BRFM Meeting with Councilor Ward Sutherland

Concerns about the Bowness Barrier Project

Figure - Bowness North Flood Inundation Map from AE Report

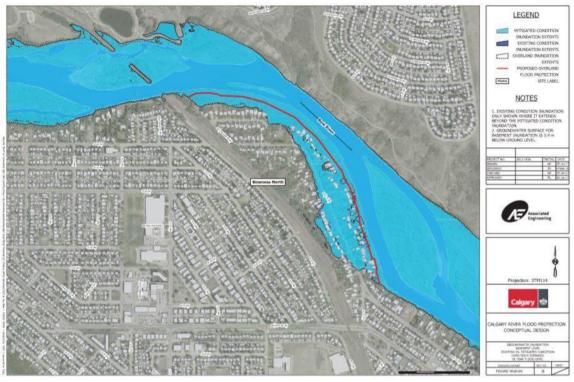
The AE report states an assumption that homes main floors were 0.3m above ground Level and therefore any inundation from overland flooding above this level would result in main floor water damage. The City has verbally indicated, and we concur, that the majority of homes have the main floor higher than the 2013 Flood level. This means, and the City conceded this point in our meeting on October 25th, that the damages are being over estimated. This then results in an inflated Benefit Cost Ratio.

Based on our understanding of the maps and the associated data in the AE report, it is only the areas that are shaded in dark blue that will not be flooded if the barrier is built. All other light blue areas will be flooded by groundwater if the barrier is built.
